7. Zoning By-Law Amendment – 1705 Carling Avenue
Modification du Règlement de zonage – 1705, avenue Carling

Committee / Commission: Planning Committee
Comité / Commission : Comité de l'urbanisme
Report / Agenda: ACS2021-PIE-PS-0031 / Item 7, Agenda 37
Rapport / Ordre du jour:

Re: Technical Amendment to Zoning Details

SUBJECT: Zoning By-law Amendment – 1705 Carling Avenue

Appendix 1: Revised Document 1– Location and Zoning Map

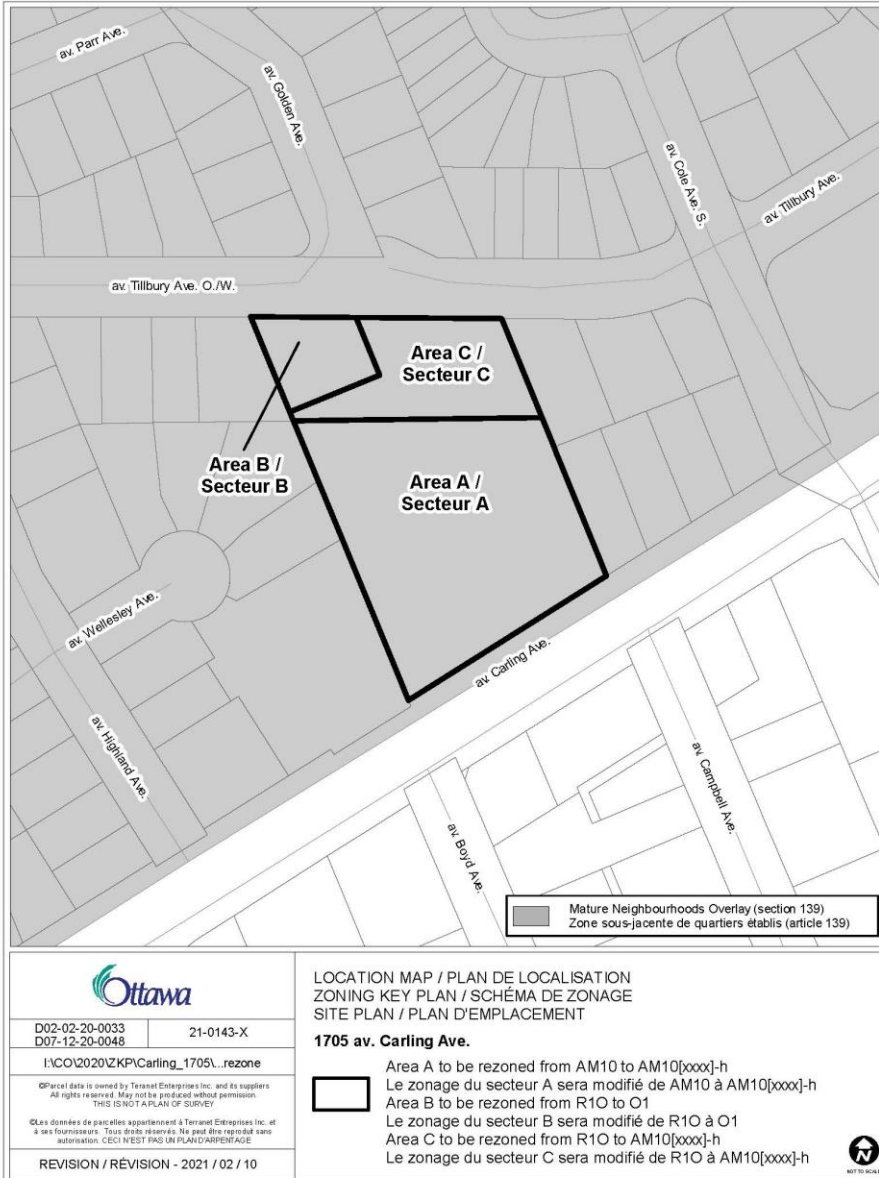
WHEREAS the location and zoning map in Document 1 does not include reference to the existing R1O zoning designation; and

- 1. Replace Document 1 of Report ACS2021-PIE-PS-0031 with a revised location and zoning map referencing the existing R1O zoning designation, listed as Appendix 1 to this motion;**

- a. replace Document 1 of Report ACS2021-PIE-PS-0031 with a revised location and zoning map referencing the existing R1O zoning designation, listed as Appendix 1 in Planning Committee Motion N° PLC 2021-37/4;

Appendix 2 – New Document 8 – Zoning Schedule

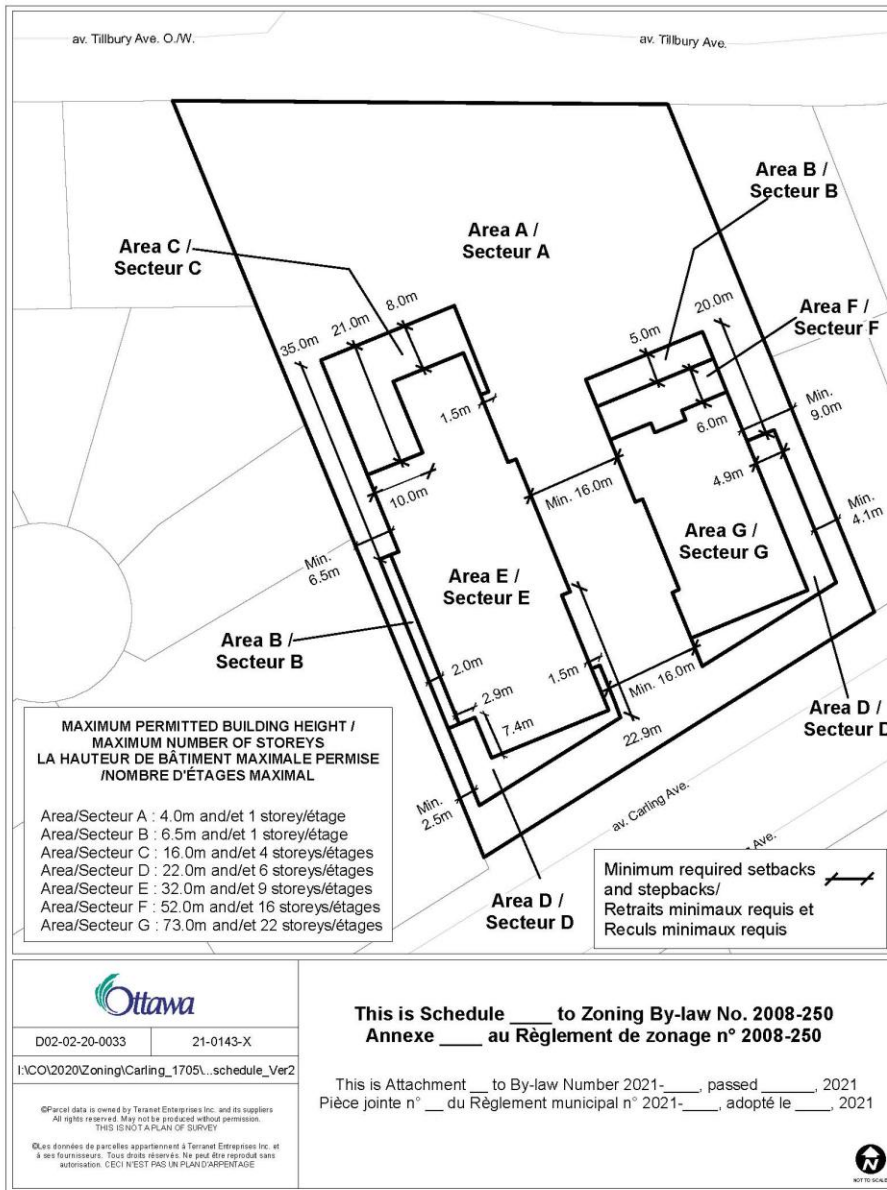
WHEREAS staff have been made aware of a desire by the Ward Councillor and the community to place further zoning limits on the heights and setbacks of the buildings being proposed as to restrict the development to what is shown in the associated Site Plan; and

WHEREAS the heights included in the newly created Zoning Schedule shall not restrict permitted projections, such as balconies and mechanical penthouses;

WHEREAS, to provide more clarity and to ensure alignment with the corresponding site plan control application for this property, staff propose to add a zoning schedule to be listed as Document 8 of this report; and

2. Add a new 'Document 8 – Zoning Schedule' to Report ACS2021-PIE-PS-0031, listed as Appendix 2 to this motion;
3. Amend Document 2 to introduce a new the Zoning Schedule, and include wording: 'Amend Part 17, by adding a new Schedule "YYY", as shown in Document 8';
4. Amend Document 2 to remove 2(c)(ii),(iii),and(iv), as these will instead be clearly referenced in Document 8.
5. Amend Document 2 to include the provision "Permitted projections listed in Section 64 and 65 are not subject to the height limits identified on SYYY" in Column V.
6. Amend Document 2 to replace any reference of "AM10[xxxx]-h" to "AM10[xxxx]SYYY-h".

- b. add a new 'Document 8 – Zoning Schedule' to Report ACS2021-PIE-PS-0031, listed as Appendix 2 in Planning Committee Motion N° PLC 2021-37/4;
 - c. amend Document 2 to introduce a new the Zoning Schedule, and include wording: 'Amend Part 17, by adding a new Schedule "YYY", as shown in Document 8';

- d. amend Document 2 to remove 2(c)(ii),(iii),and(iv), as these will instead be clearly referenced in Document 8;
 - e. amend Document 2 to include the provision "Permitted projections listed in Section 64 and 65 are not subject to the height limits identified on SYYY" in Column V;

- f. amend Document 2 to replace any reference of "AM10[xxxx]-h" to "AM10[xxxx]SYYY-h".
2. that there be no further notice pursuant to subsection 34 (17) of the Planning Act.
